CCK-0084-3-26

Entomology Research and Education Center

ADDENDUM #3

Addendum #3

POWER AND SYSTEMS PLAN

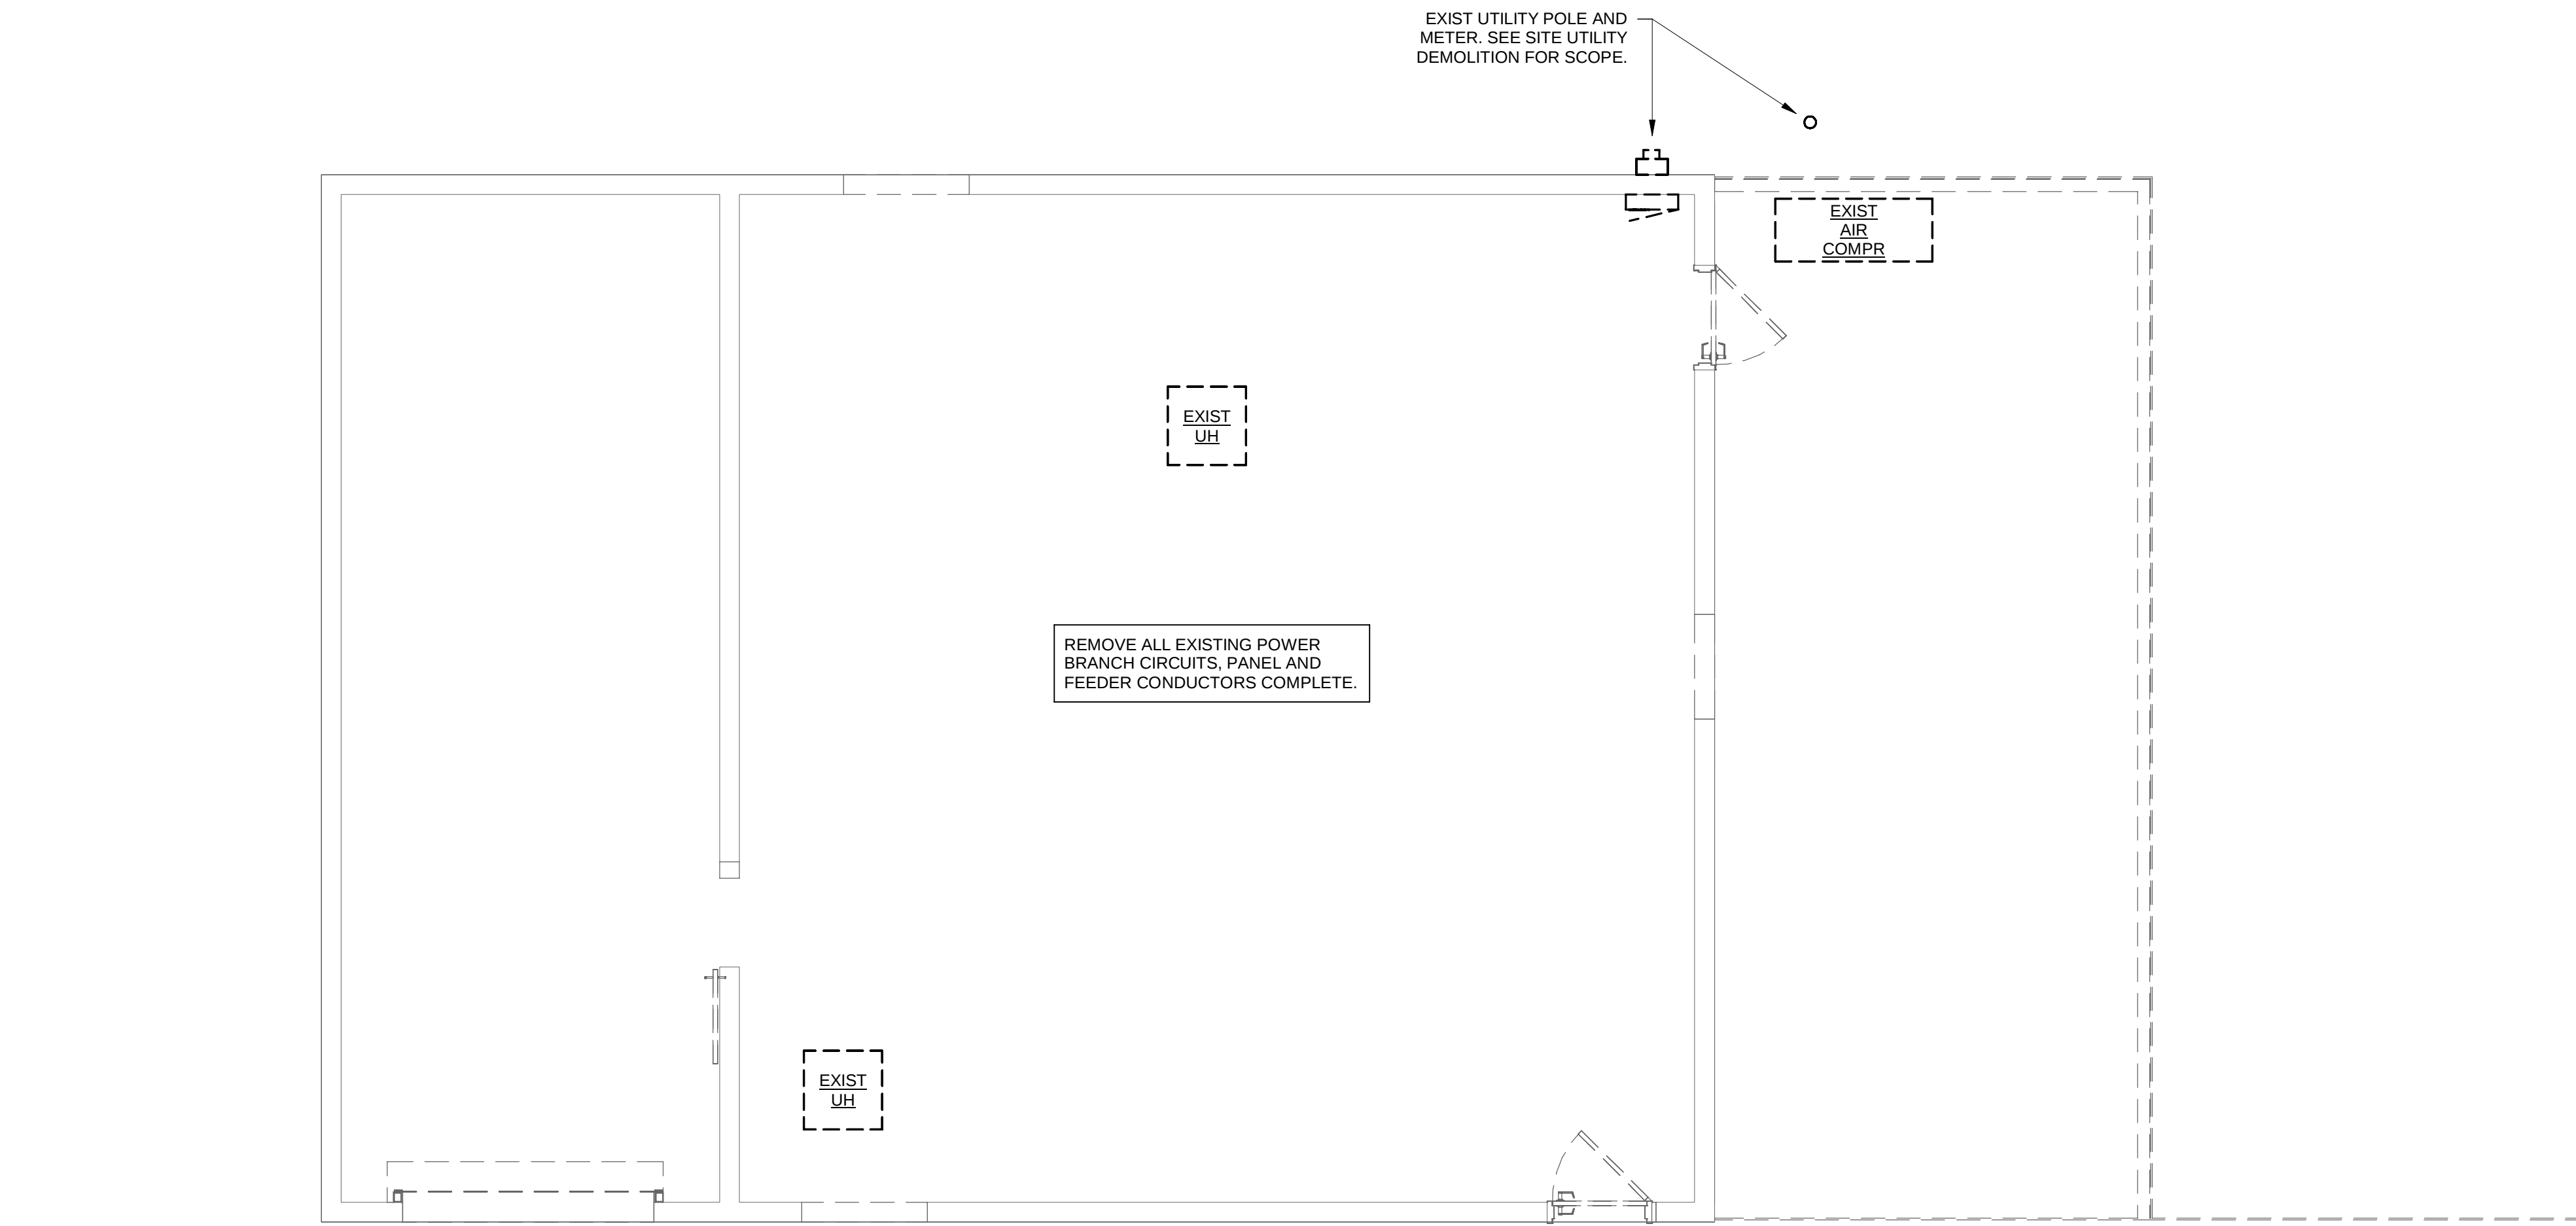
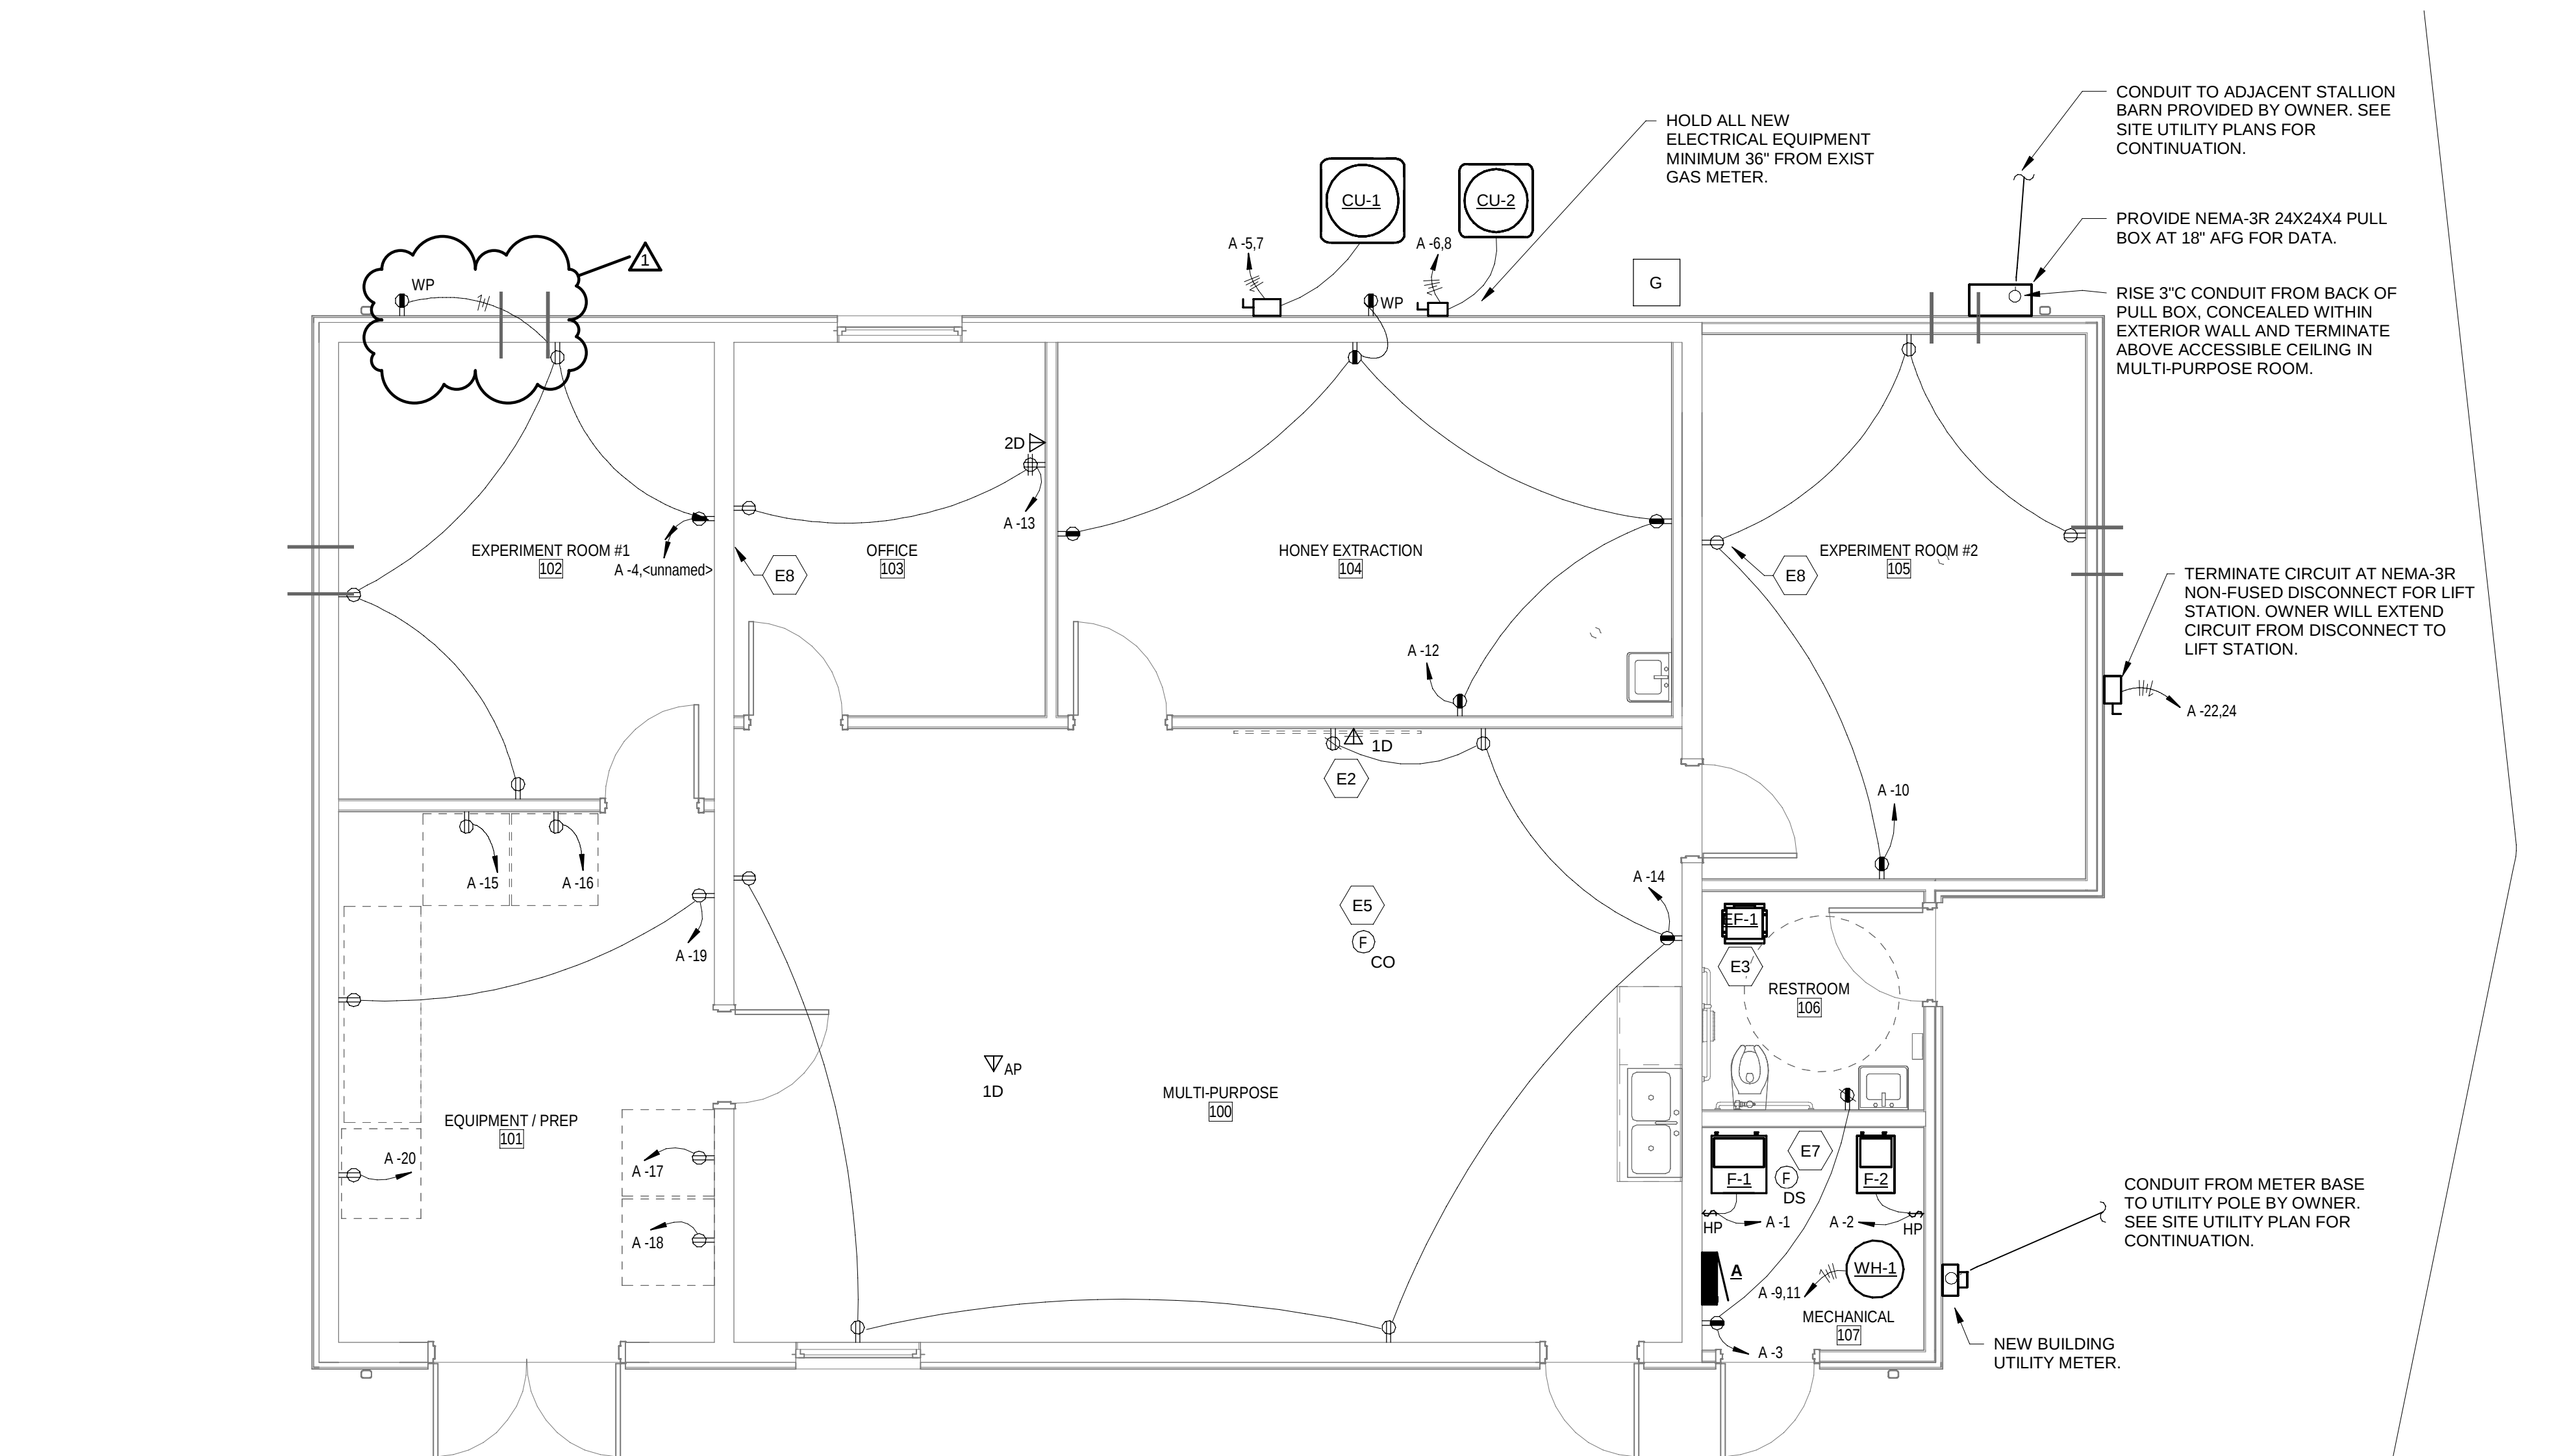
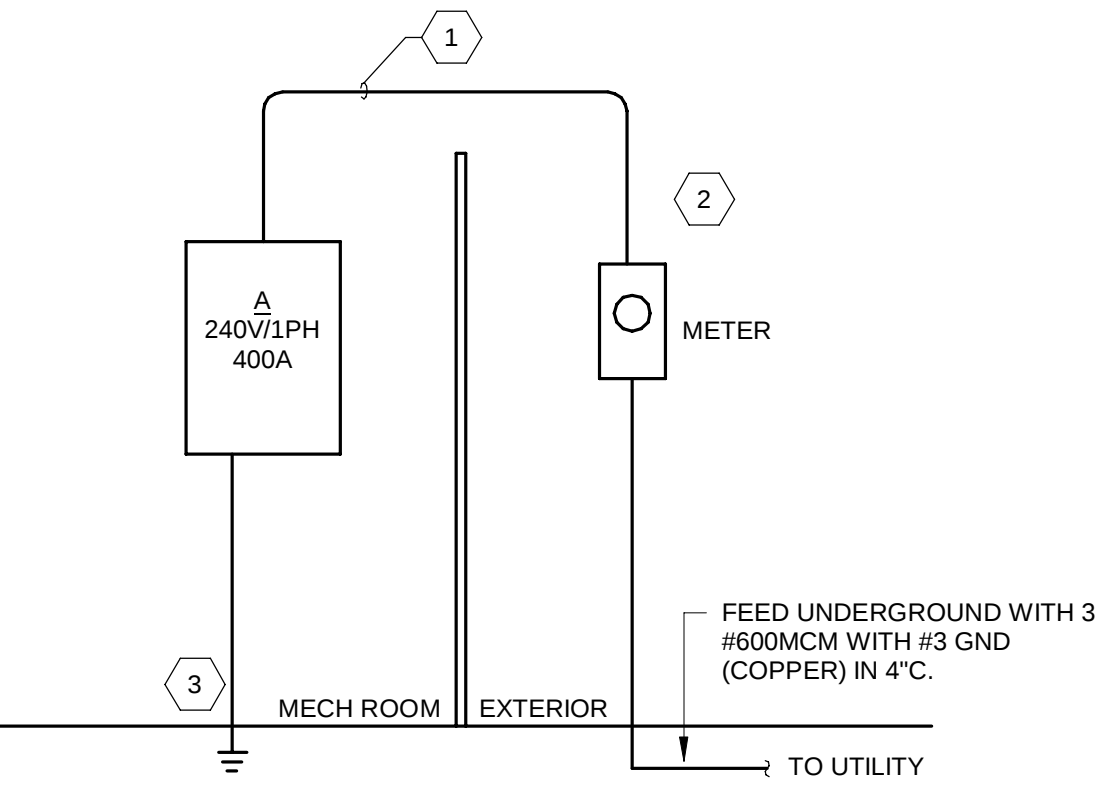
17. A111 Floor Plan Note 4 shows a projector screen. What is the projector screen, and how is it attached?

A: The design intent is for a wall mounted TV, not a projector screen. The owner will furnish the TV. GC will provide blocking in wall for the TV mount.

- E2 INSTALL POWER & DATA OUTLET CONCEALED BEHIND TV. FIELD COORDINATE EXACT LOCATION OF TV WITH ARCHITECT PRIOR TO ROUGH-IN.
- E3 FEED EXHAUST FAN FROM LIGHTING CIRCUIT THIS ROOM, CONTROL VIA LIGHT SWITCH OCCUPANCY SENSOR.
- E5 PROVIDE STAND-ALONE COMBO SMOKE AND CO DETECTOR EQUAL TO KIDDE MODEL 12010SCO. FEED FROM ROOM'S RECEPTACLE CIRCUIT.
- E7 PROVIDE STAND-ALONE RETURN DUCT SMOKE DETECTOR EQUAL TO SIMPLEX MODEL 4096-9687. INSTALL DETECTOR IN ACCESSIBLE LOCATION. UPON DETECTION OF SMOKE, FAN SHALL SHUT OFF.
- E8 RECEPTACLES INSTALLED EXIST CMU WALLS SHALL BE IN SURFACE MOUNTED RACEWAY EQUAL TO WIREMOLD 2400 SERIES. RACEWAY COLOR SELECTED BY ARCHITECT.
